Letter from C. R. Steinhardt (WPSC)

Document Control Desk (NRC)

Proposed Amendment 139a

Affected TS Pages:

FIGURE TS 3.1-4 LOW TEMPERATURE OVERPRESSURE PROTECTION CURVE APPLICABLE FOR FLUENCE UP TO END OF OPERATING CYCLE 33

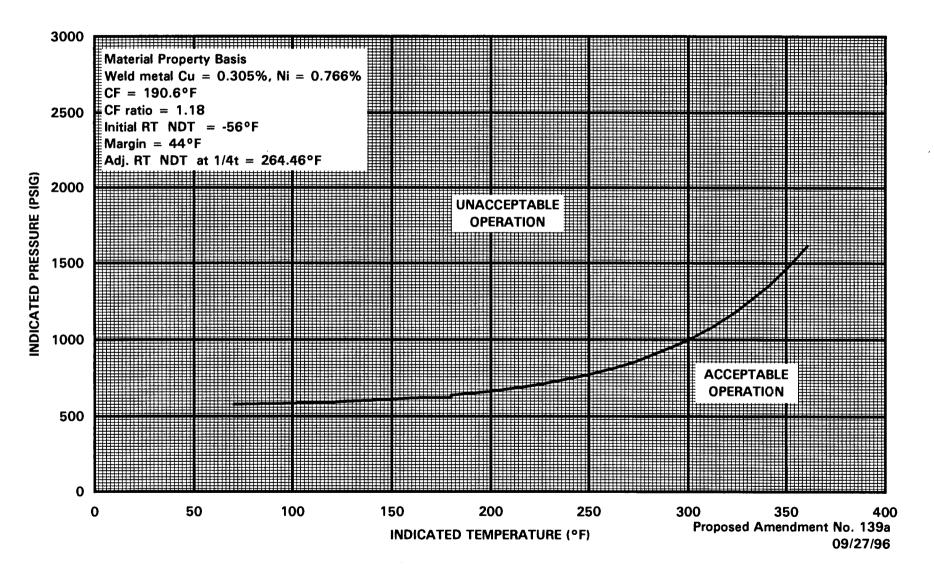
- b. Heatup and Cooldown Limit Curves for Normal Operation
 - 1. The reactor coolant temperature and pressure and system heatup and cooldown rates (with the exception of the pressurizer) shall be limited in accordance with Figures TS 3.1-1, TS 3.1-2, and TS 3.1-4. Figures TS 3.1-1 and TS 3.1-2 are applicable for the service period of up to 20 effective full-power years. Figure TS 3.1-4 is applicable through the end of operating cycle 33 or 33.41 effective full-power years.

- C. Figure TS 3.1-4 defines limits to assure prevention of non-ductile failure applicable to low temperature overpressurization events only. Application of this curve is limited to evaluation of LTOP events whenever one or more of the RCS cold leg temperatures are less than or equal to the LTOP enabling temperature of 355°F.

The low temperature overpressure protection system must be OPERABLE during startup and shutdown conditions below the enable temperature (i.e., low temperature) as defined in Branch Technical Position RSB 5-2. Based on the Kewaunee Appendix G LTOP protection pressure-temperature limits calculated through 33.41 effective full-power years, the LTOP System must be OPERABLE whenever one or more of the RCS cold leg temperatures are \leq 355°F and the head is on the reactor vessel. The LTOP system is considered operable when all 4 valves on the RHR suction piping (valves RHR-1A, 1B, 2A, 2B) are open and valve RHR-33-1, the LTOP valve, is able to relieve RCS overpressure events without violating Figure TS 3.1-4.
